RECEIPT DATE: 1/9/2024 **ONSITE SEWAGE DISPOSAL SYSTEM** P 75764

APPROVAL DATE: 2/2/2024 **PERMIT: REPAIR** A _____

PROPERTY ADDRESS: 16964 Moss Meadow Way, Mt. Airy, 21771

SITE INSPECTION SHEET

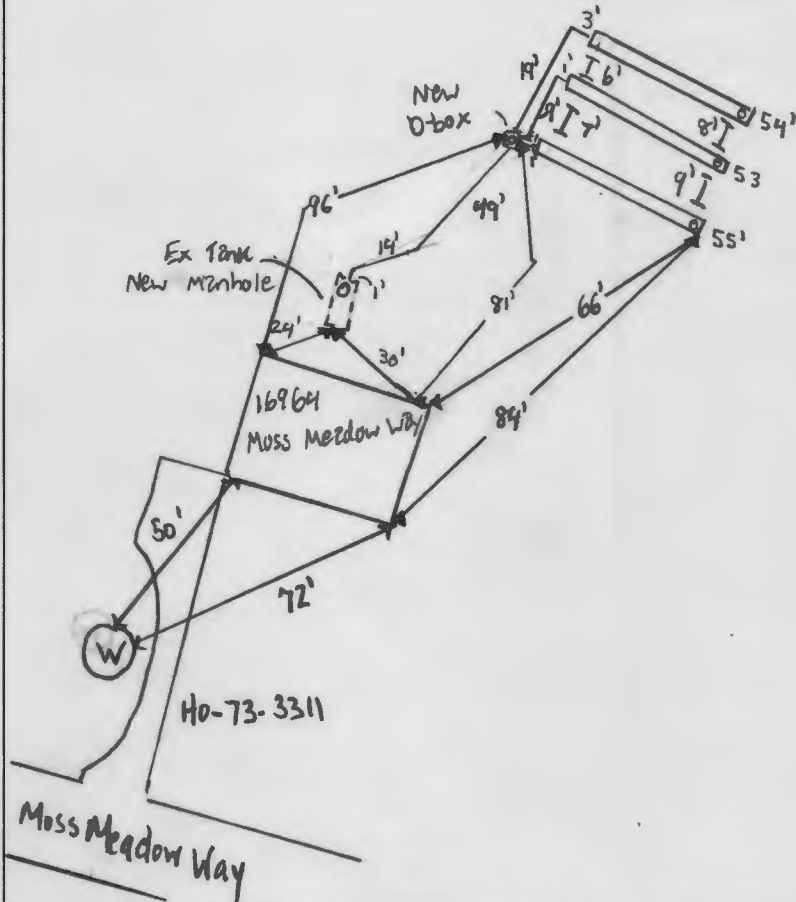
1/4/24 - perc testing complete. 545% rock at both perc holes, appropriate

for conventional system will 0.6 gpd/sqft for 3 bedrooms, laid out a system w/ the contractor shooting elevation for 3x52' trenches over perc hole B, use existing 1000 g Septic tank, abandon old d box and initial trench system (all 3 existing trenches are blocked) contractor to supply a septic repair plan for installation notes: review 1/18/24. Plan submitted & approved OK to start work. (P)

2/2/2024 - confirmed ex septic trenches disconnected & abandoned. Ex tank has new manhole, pipe from tank to D-box using SCHD 40 PVC & hzs adequate fall. Installer stoning upper trench, inlet @ 3'-2.5'. Length of trenches @ 54', 53', & 55'. D-box purged while onsite, D-box revealed onsite. OK to backfill all work. Space between trenches 6'-9'; edge to edge & 9'-12' center to center (P)

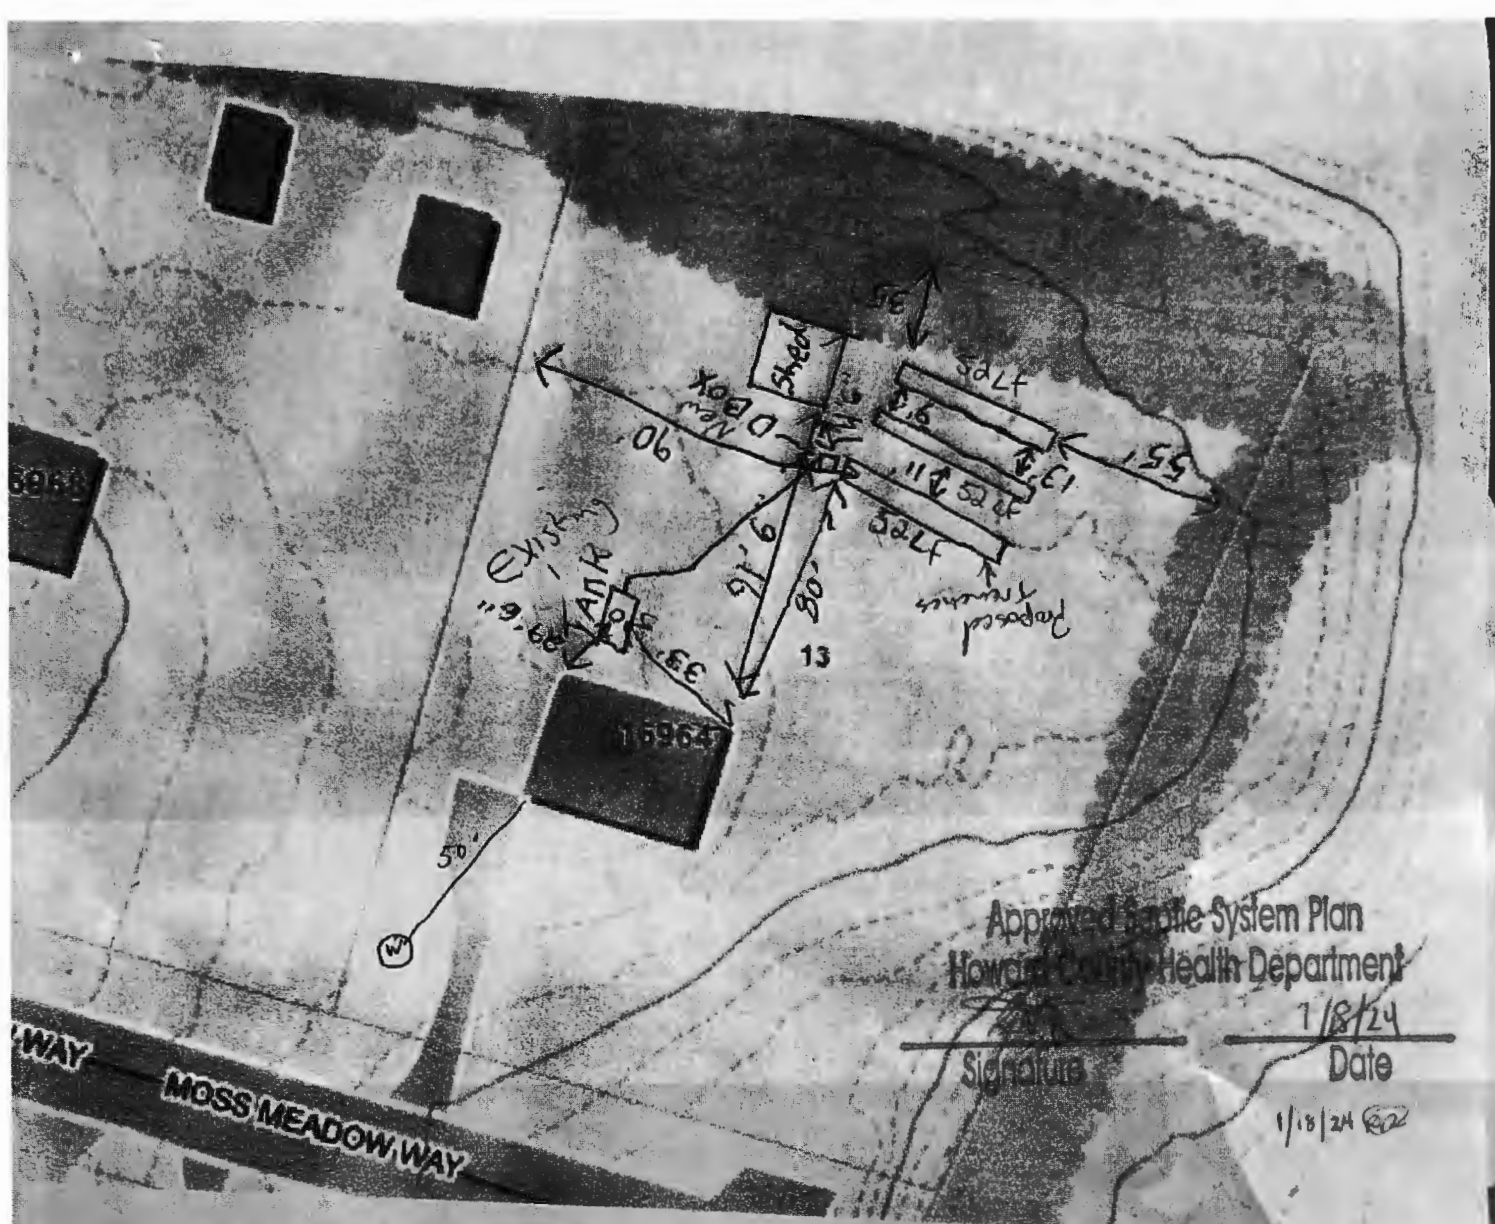
Hatfields Equipment Inc Existing tank to remain

Existing septic drain fields to be abandon

Install 3- 52cf trenches ^{3' wide} 6ft deep 3ft stone
3ft inlet 1- large distribution box

Existing system to be disconnected and abandoned

LOCATION DIAGRAM

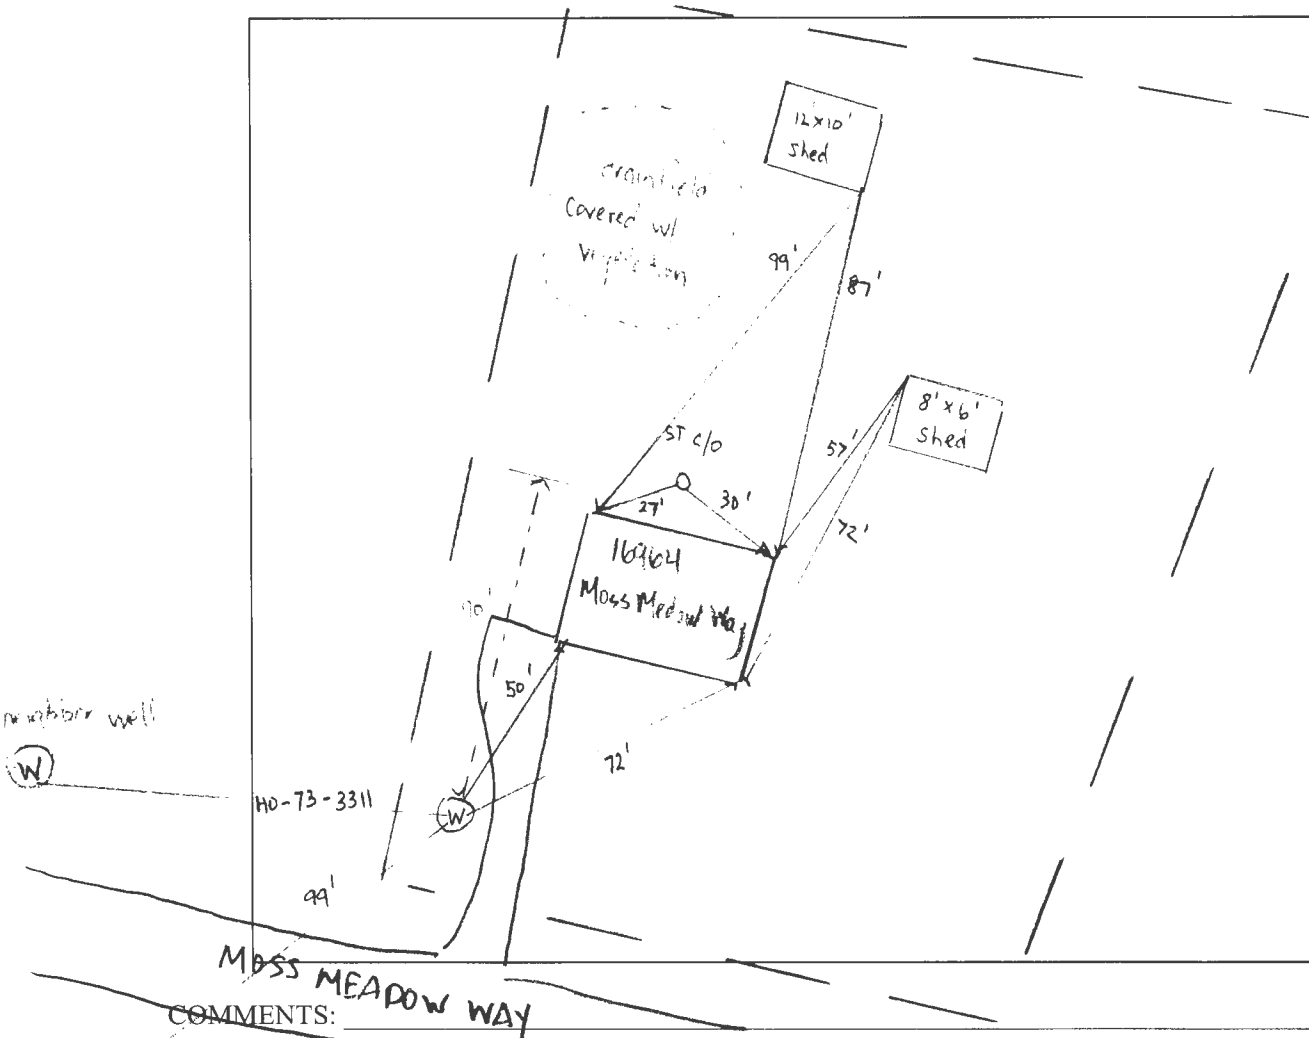
Evidence of overflow at the septic tank c/o, east property line over 200' away from stream buffer (75') - septic tank to well is right at about a 100' setback - (possible perc in NE corner of property)
